## **Alberta Electric System Operator**

### **2018 Independent System Operator Tariff**

**Alberta Utilities Commission**  
Decision 22942-D02-2019  
Alberta Electric System Operator  
2018 ISO Tariff Application  
Proceeding 22942

Figure 1. Linearized POD cost function (cost versus MW)<sup>158</sup>

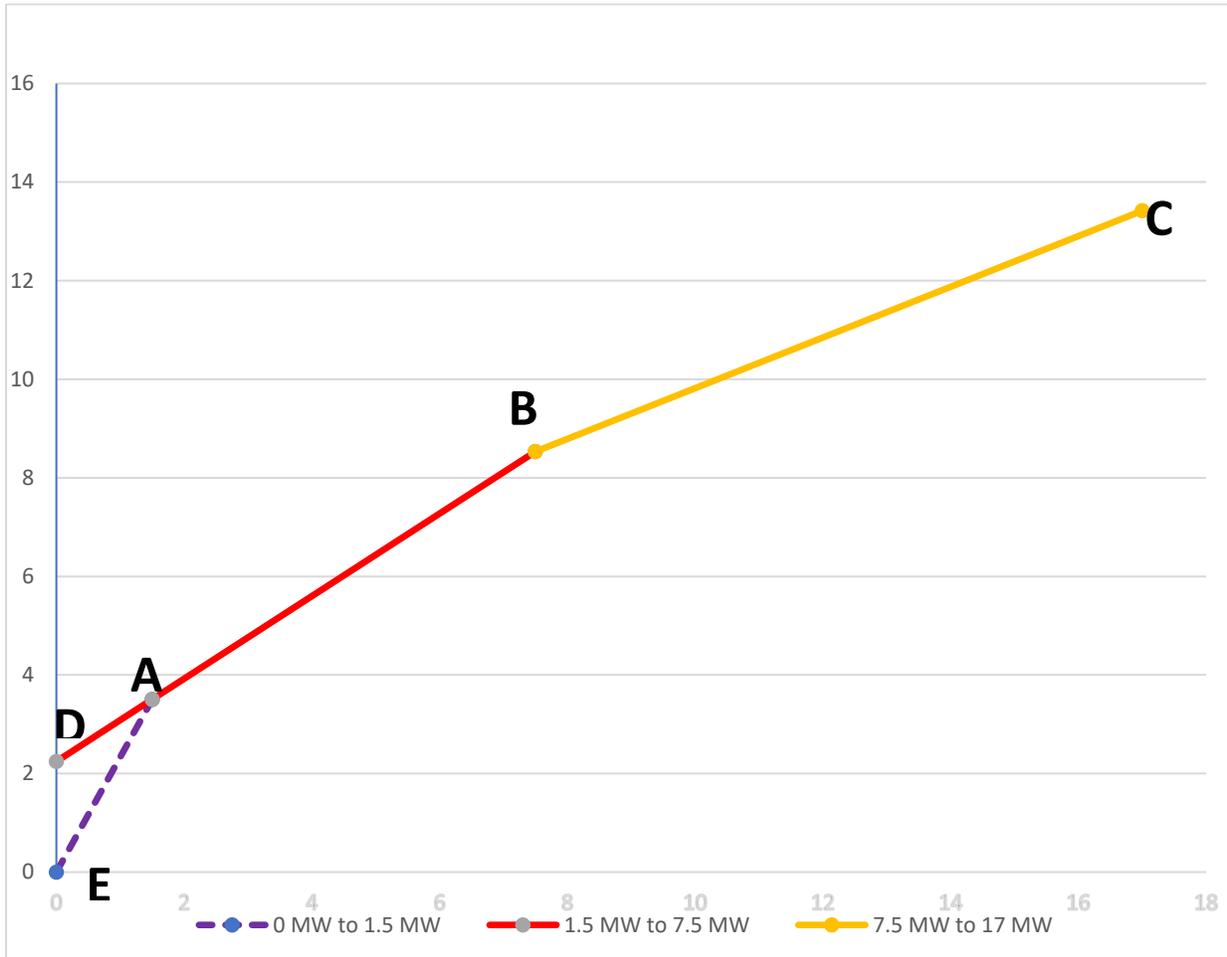
163. Second, the way that the intercept is determined, by extending the slope of the line segment between the estimated value of the POD cost function at 1.5 MW and at 7.5 MW back to the vertical axis (where MW=0), from Point “A” to Point “D” in Figure 1, makes the choice of the MW values that define this line segment critical. For example, if the segment was defined as being between 1 MW and 7.5 MW instead of between 1.5 MW and 7.5 MW, this segment would have a different slope, and extending that back to the vertical axis would yield a completely different intercept. Although the MW values defining the line segments were agreed to by the

**Figure 3. Comparison of AESO contributions closing rate base between DFOs**

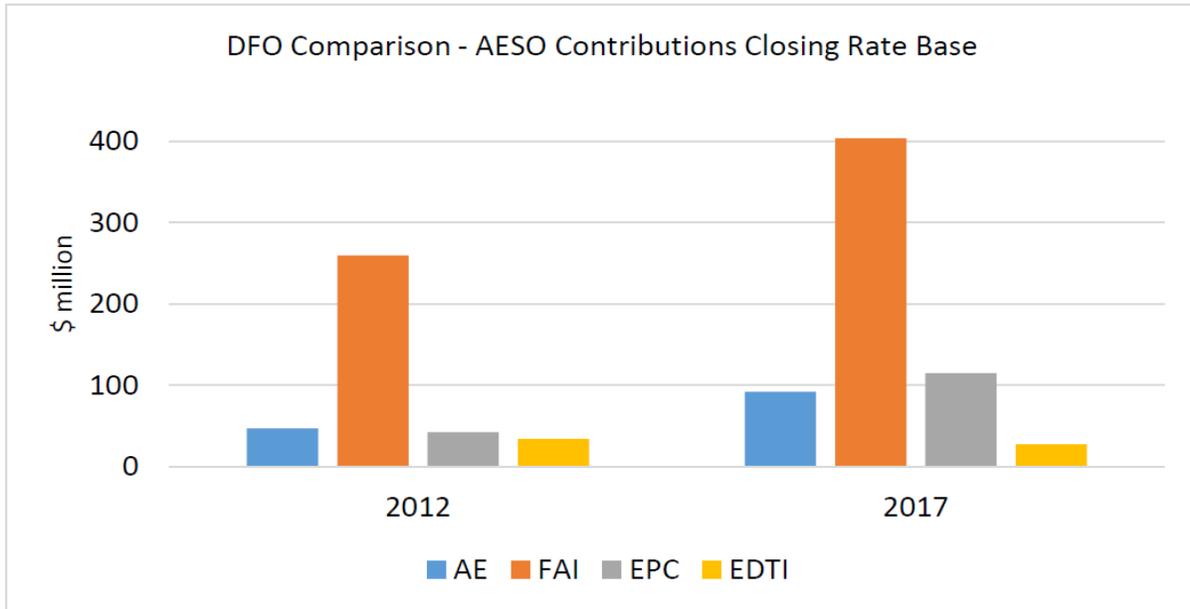
1004. The Commission notes that AltaLink illustrates the difference between Fortis and other Alberta DFOs in Figure 1-3 from its argument, reproduced below:
